**PLANNING BOARD AGENDA**  
**OCTOBER 14, 2021 – 7:00 P.M.**

**RESPONSE TO TOWN CONSULTANT COMMENTS**

Fante, 419 Union Valley Road, Carmel (T)

RE: Amended Site Plan  
Hamlet at Carmel  
TM# 66.-2-58

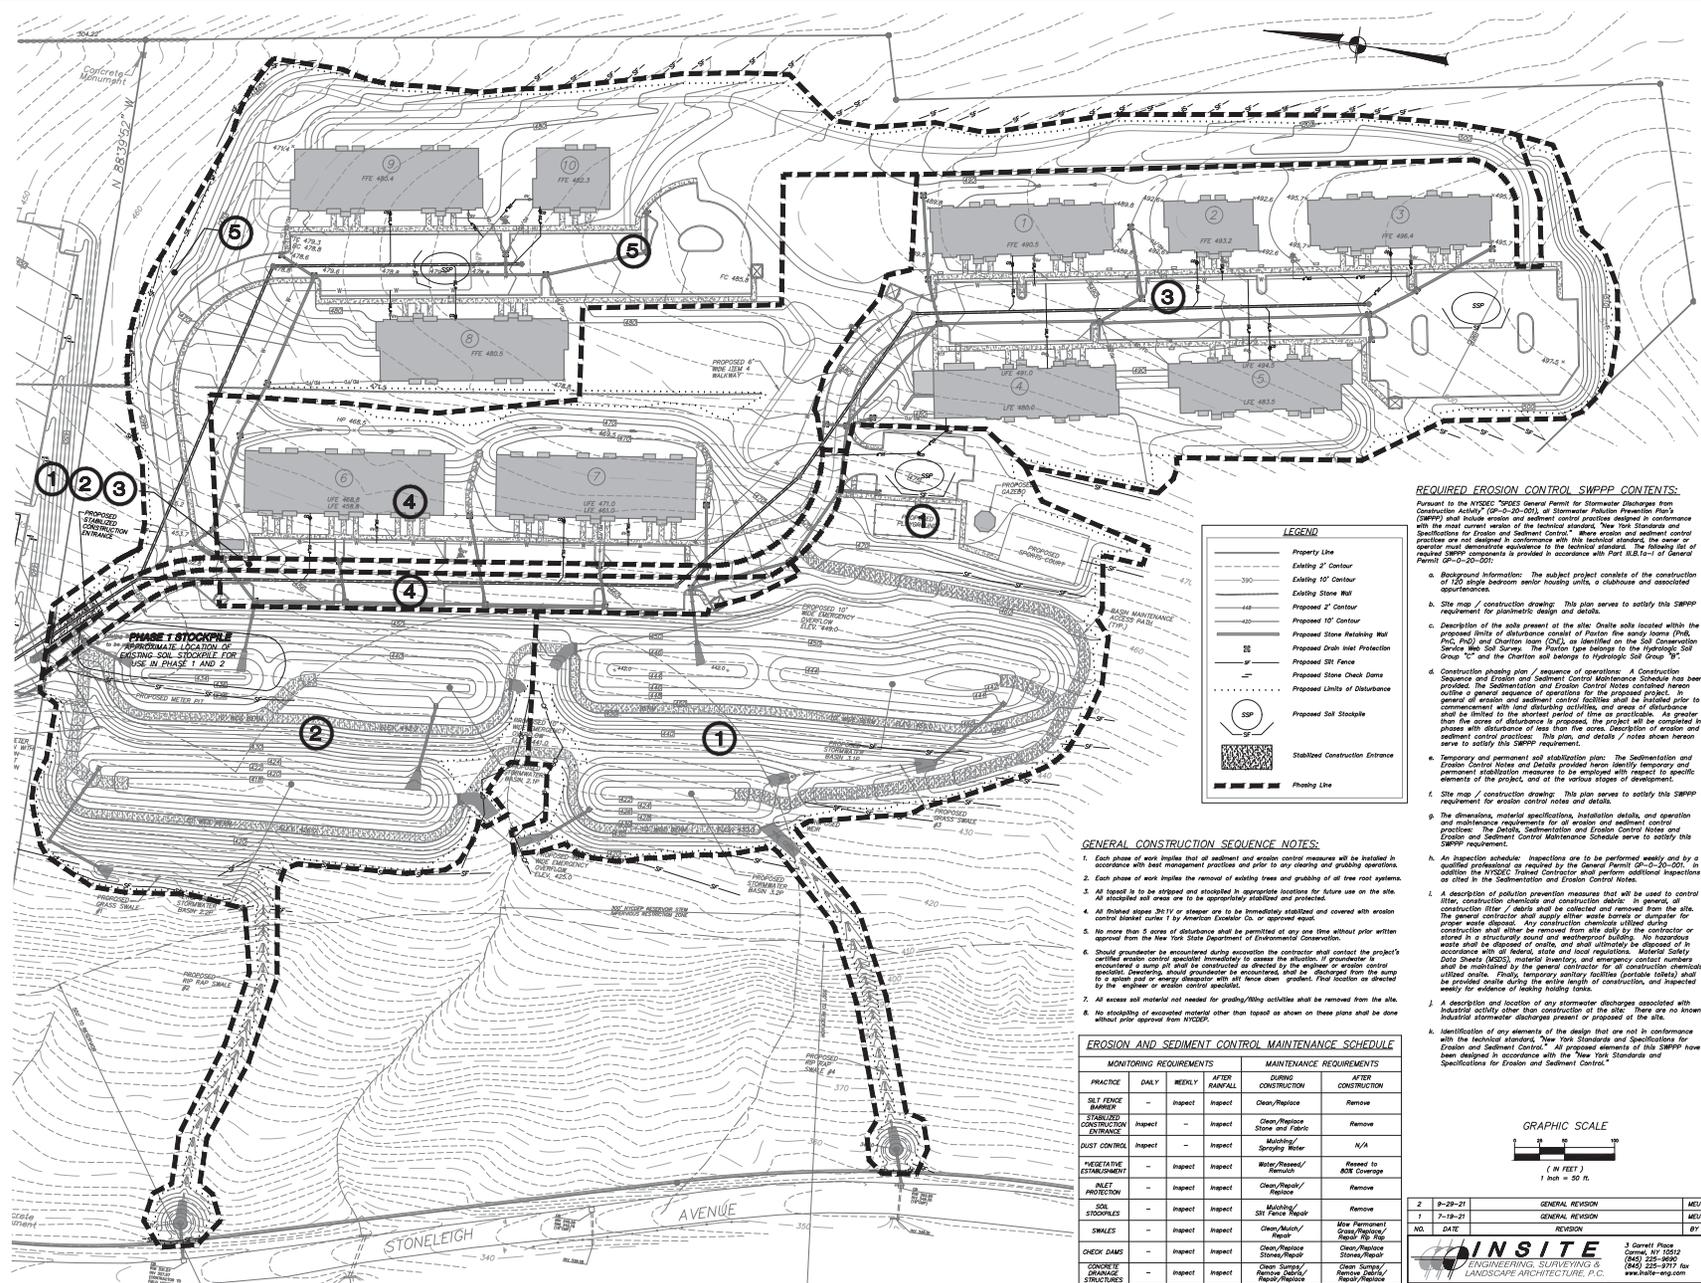
2. Stormwater will be managed as depicted on drawing SP-3 of the Site Plans. A collection system has been designed with drain inlets, catch basins, yard drains, and roof and footing drains that will be conveyed to stormwater basins to the west of the site.

3. It is understood that the site landscaping will be reviewed by the Town Wetland Inspector.
4. Rim and invert elevations and hydraulic sizing calculations for proposed drainage structures will be provided in a future submission. The proposed water and sewer infrastructure have been shown on Drawing SP 3.
